Scott Horsley
Water Resources Consultant
65 Little River Road • Cotuit, MA 02635 • 508-364-7818

September 13, 2023

RE: 24 School Street, Wayland NOI Application

RE: 24 School Street, Wayland

Figure 1 - USGS Topographic Quadrangle 1970

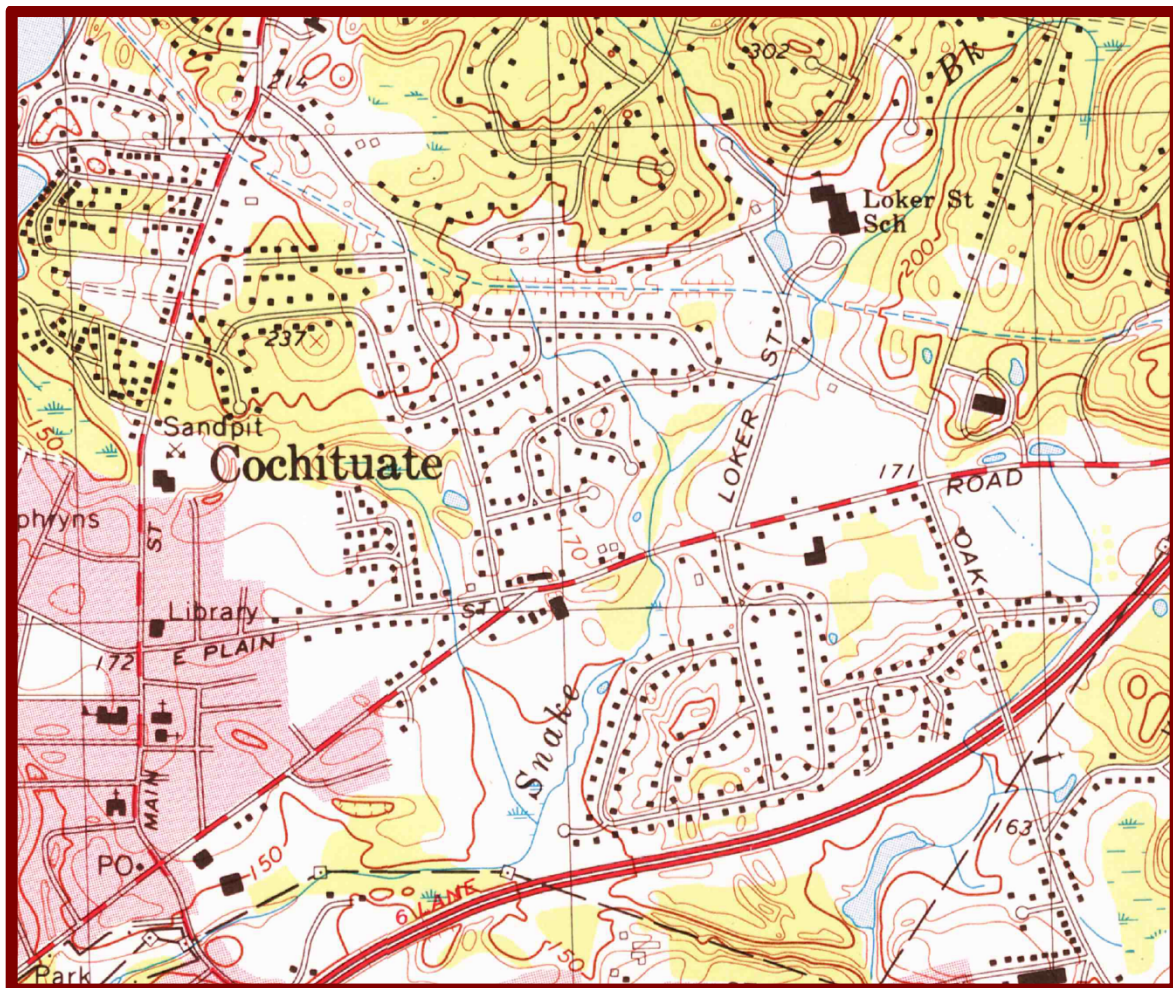
a) the stream was mapped as perennial by the USGS (1970 Quadrangle). The stream is depicted on the Quadrangle by a solid blue line, similarly to the depiction of Snake River. By contrast a different stream located next to Oak Stream is depicted as intermittent, by dashed lines.

Figure 2 - Effects of Water Use and Land Use on Streamflow and Aquatic Habitat in the Sudbury and Assabet River Basins, Massachusetts" (Scientific Investigations Report 2010-5042)

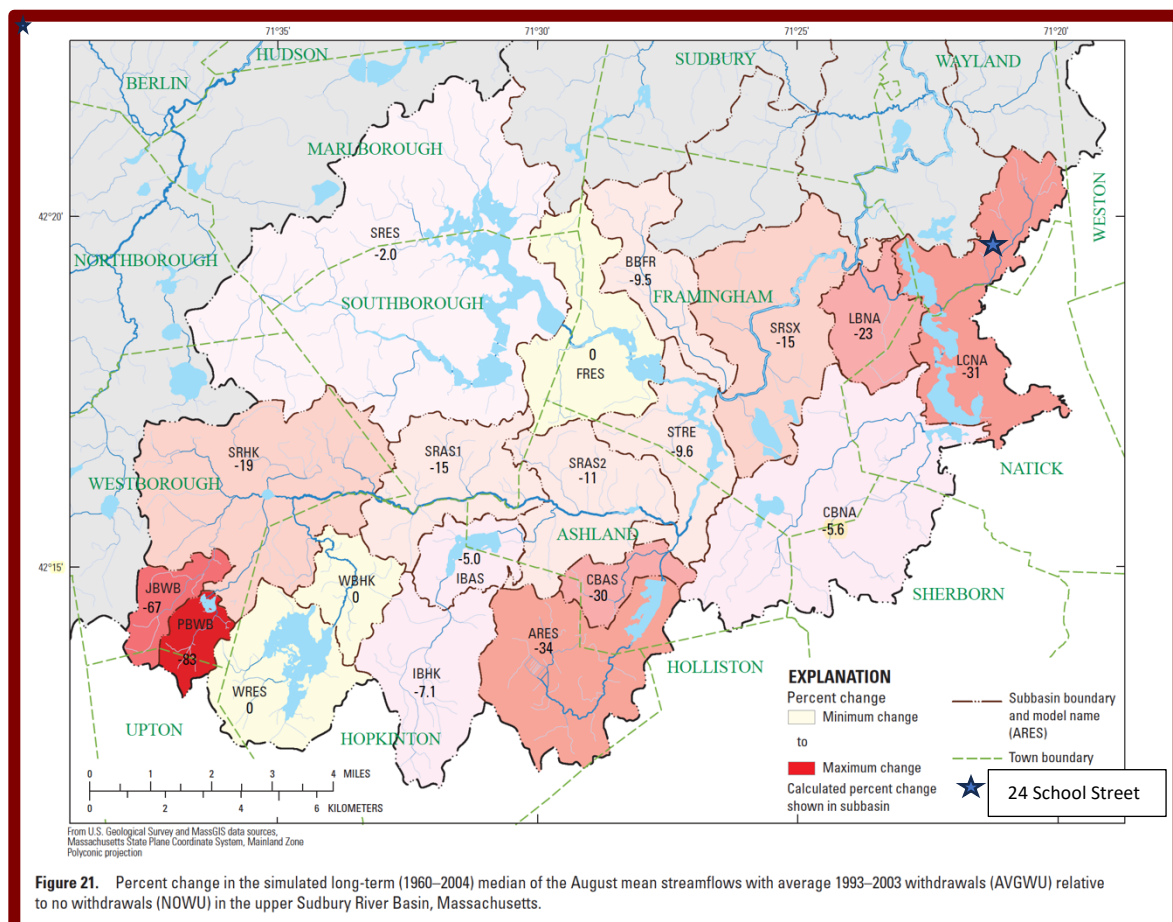
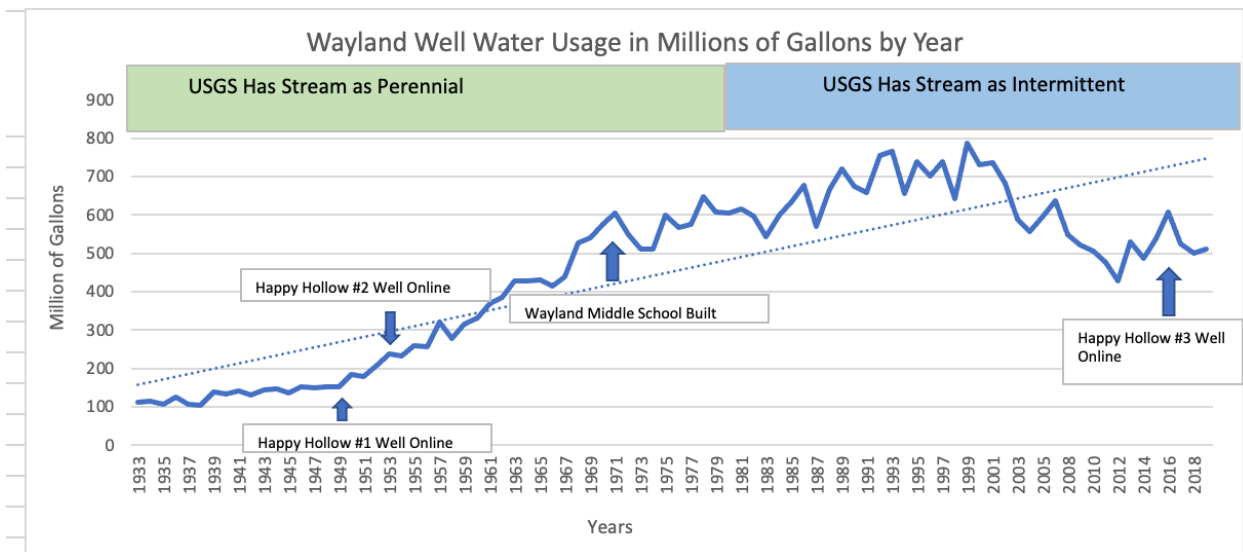
c) the stream is within a subwatershed identified as significantly de-watered (affected) by water supply withdrawals and impervious surfaces (-31%) by the USGS model of the Sudbury and Assabet Rivers. There are nine public water supply wells that withdraw water from this subwatershed that surround the project site (see attached excerpt from USGS report). Some of these wells withdraw in excess of 1 million gallons/day and have water level drawdowns that extend for thousands of feet. These individual drawdowns from each well are cumulative and additive. The pumping of Wayland wells has increased significantly over time (see attached graph). The creation of impervious surfaces (including the nearby school building and parking lot) within the watershed has also reduced groundwater recharge and baseflow in the stream (see attached map showing impervious surfaces).

Wayland Stream Analysis 071321

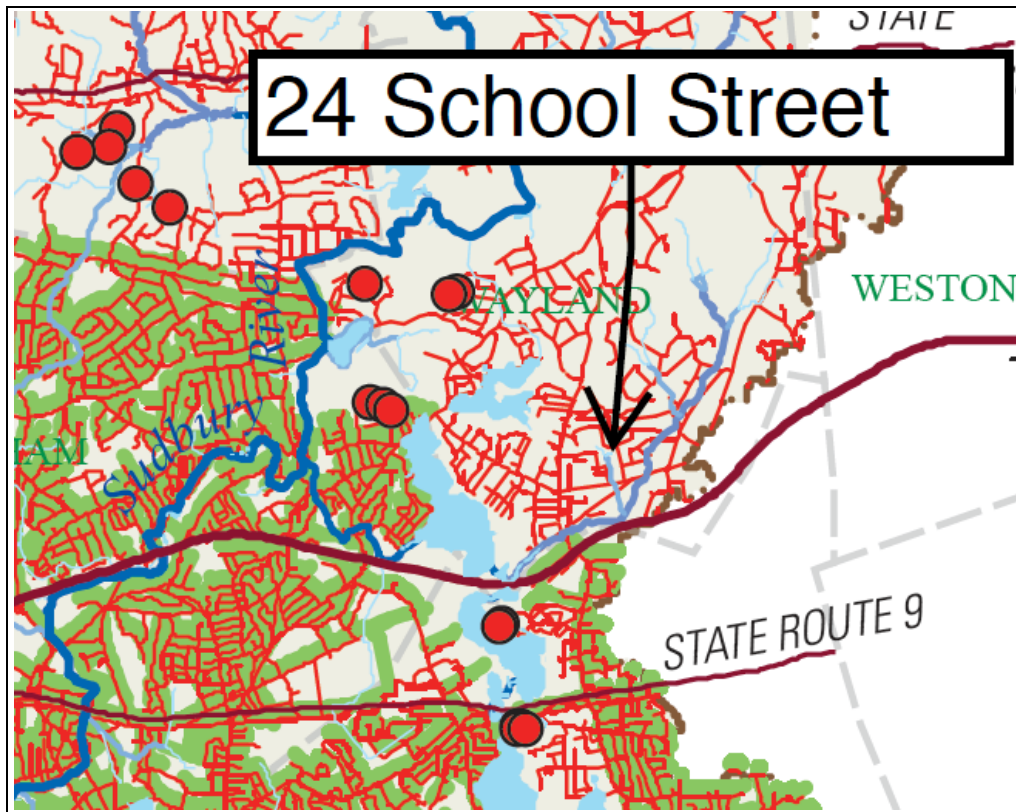
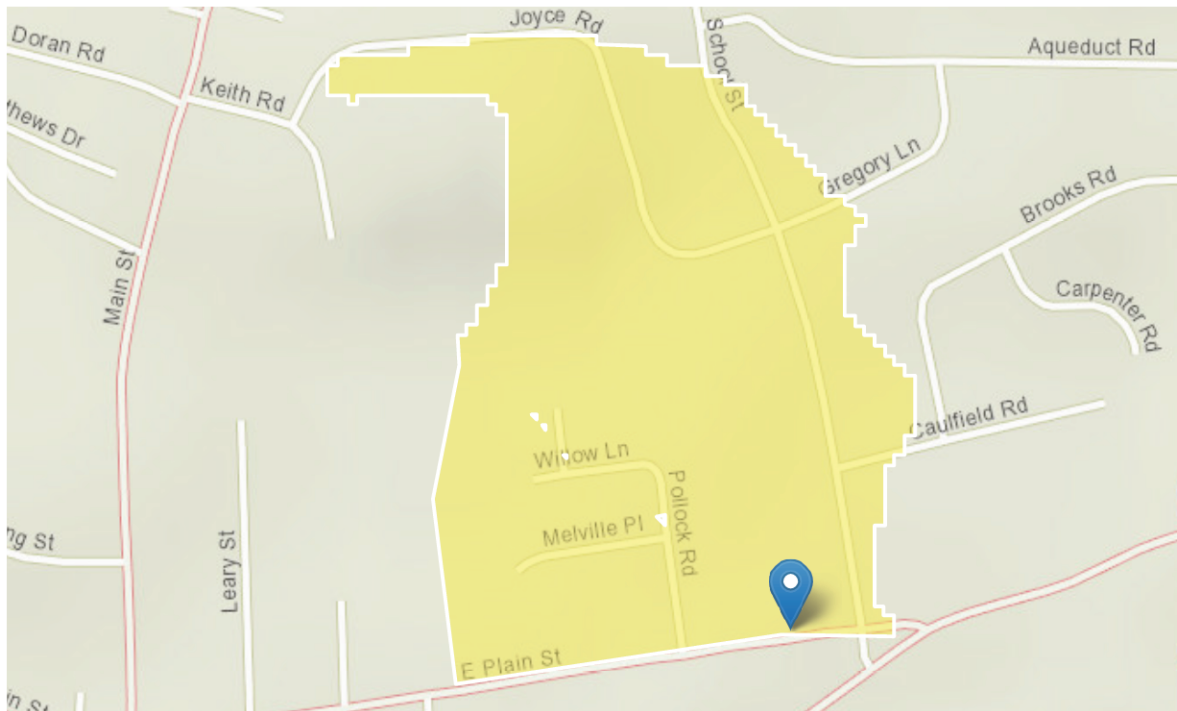
b) The USGS StreamStats analysis identifies the stream as having a perennial probability of 0.65 (over the 0.56 criterion). This information was not included with the peer reviewer's (EcoTek) comment letter.

Figure 1 - Topographic Map, USGS (1970)

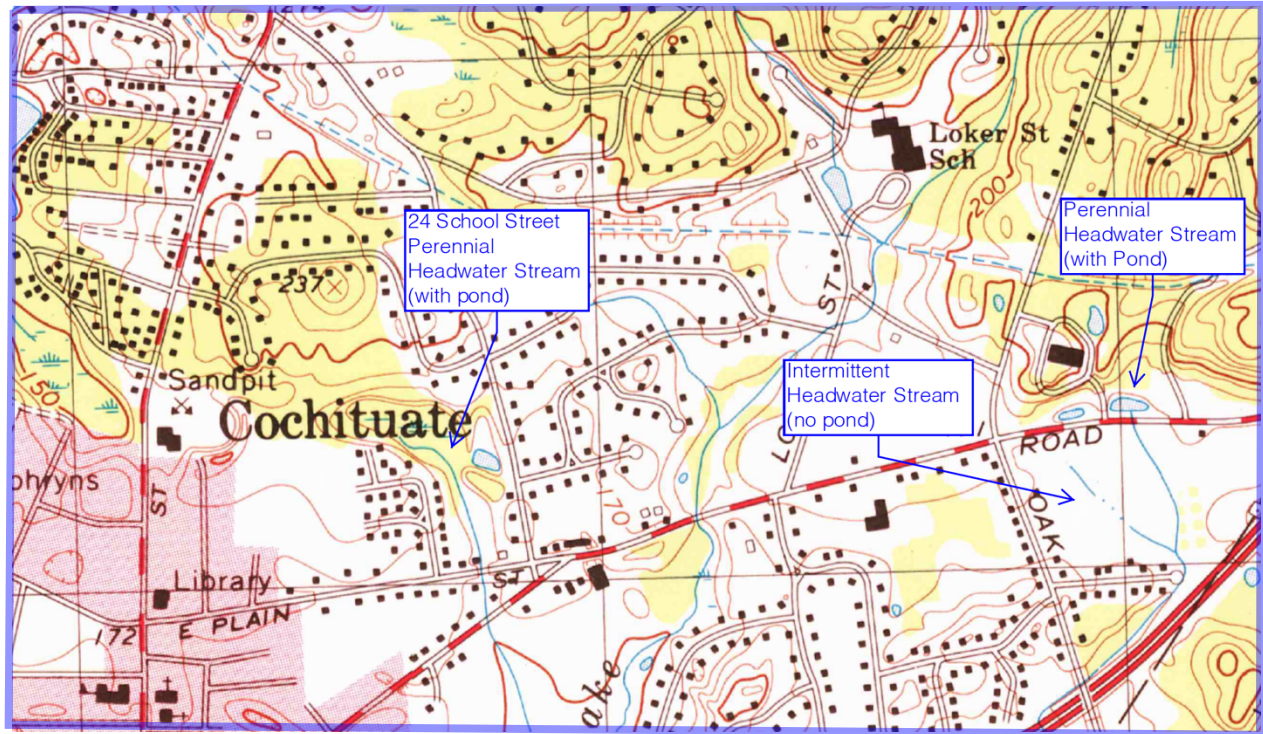
The stream is shown as perennial on the 1970 topographic map published by the United States Geological Survey (USGS) – (see attached figure 1). This figure shows the subject stream as a solid line (indicating perennial) and for comparison another small stream to the east shows as a dashed line (indicating intermittent). There is another small headwater stream to the east that shows as perennial. Note that the two perennial streams have ponds at their source. The intermittent headwater stream does not have a pond. The ponds function to store water and sustain flow during the drier season thus maintaining the perennial flow.

The 1987 topographic map published by USGS shows the stream as intermittent. This change from perennial to intermittent suggests that the stream may have had perennial flow naturally, but does not currently, possibly as a result of human-induced hydrologic modifications including water withdrawals and impervious surfaces in the area both of which serve to dewater the stream.

Figure 2 - Watershed Modeling Results (USGS)

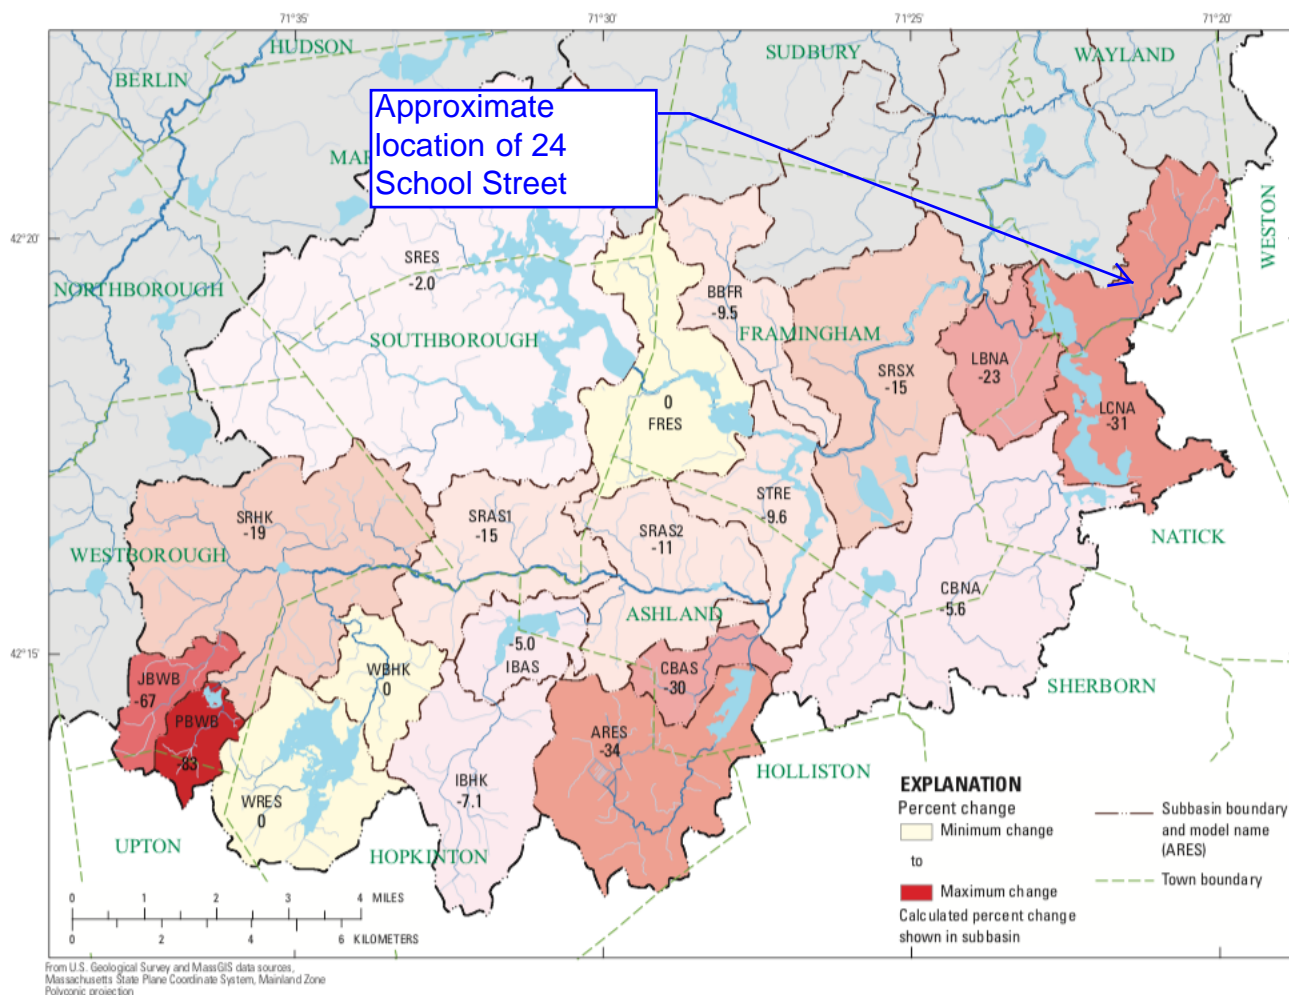
These types of human-induced withdrawals and land use developments and their impacts on stream flow were analyzed and documented by the USGS in their report, “Effects of Water Use and Land Use on Streamflow and Aquatic Habitat in the Sudbury and Assabet River Basins, Massachusetts” (Scientific Investigations Report 2010-5042). The study evaluated the cumulative effects of water withdrawals and land use changes throughout the Sudbury and Assabet River Basins on stream flow. Within the Lake Cochituate basin (LCNA) that includes the subject stream, the USGS study evaluated the impacts of 6 public supply wells in Natick (to the south of the subject project) and 8 public supply wells in Wayland (to the north of the site). Figures 20 and 21 of that report (attached) show reductions to annual stream flow and to August median flows as a result of water withdrawals. August median flows are analyzed as the low flow or baseflow condition of a perennial stream. The subject property is located in basin 17 – LCNA, which shows a -31% decline in August median streamflow and is rated as a “maximum change” (emphasis added). This study also concluded that, “simulations indicated that the average 1993 – 2003 withdrawals most altered streamflow relative to no withdrawals

in small headwater subbasins...” Both of these findings support my interpretation that the subject stream has been altered due to water withdrawals and land use changes.

Figure 3 - Water Level Data Wayland Well WKW2 (USGS)

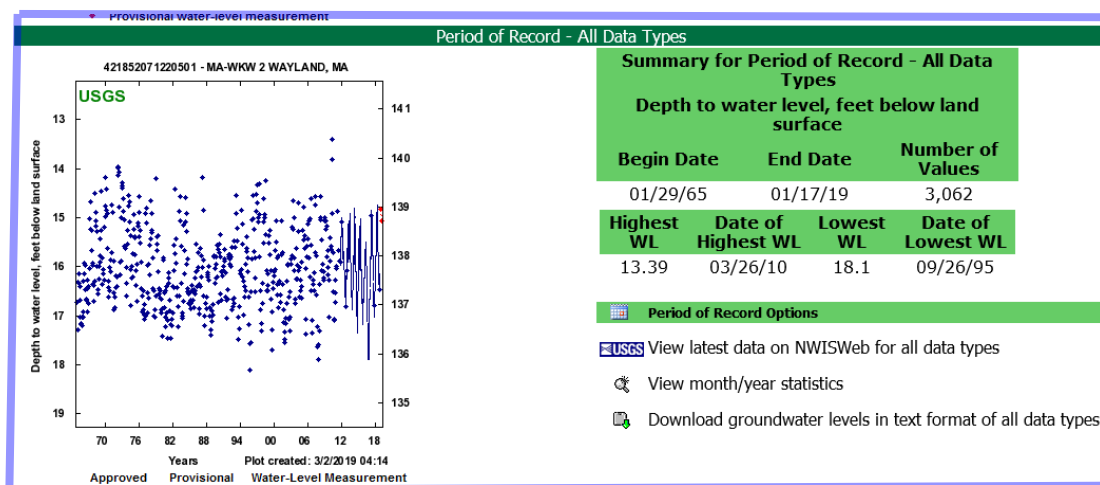
In their August 15, 2018 letter, CLAWE discusses the use of the USGS method to estimate high water table conditions. Their letter states, “We checked USGS monitoring well WKW 2 in Wayland, which would be located in the same weather zone. The monitoring data showed that the water table recorded on 3/12/18 is 14.95 ft from grade, while the highest water table recorded in April 2018 is 14.74 ft (4/28/18), and in May 2018 is 14.79 ft (5/2/18).” It goes on to say that the margin of error is 6-7” and that “the 2018 water table recorded exceeded the history high 14.80 ft (depth to water level), at the USGS monitoring well” It then states that “if the project had been done in 2016, the highest water table monitored would be more than 6” lower than what we had that year”.

However, the USGS database on this well (WKW2) shows that the highest water level (depth) recorded is 13.39 (depth to water level at the index well) measured on March 26, 2010 (see record below from USGS website). This is 1.41 feet higher than the measurement that they cite in their letter. This differential should be added to their on-site water levels in designing the septic and stormwater infiltration systems and effectively would require them to raise their base water table elevations, resulting in a re-design of the site. This higher groundwater level should be used as the static pre-development condition in the MODFLOW modeling (discussed below).

5. Provide modeled water levels throughout the 100-year storm and the 72-hour period following the event.
6. Use the higher pre-development (static) groundwater level as indicated by the USGS Index well Wayland WKW2 as stated previously in this letter.
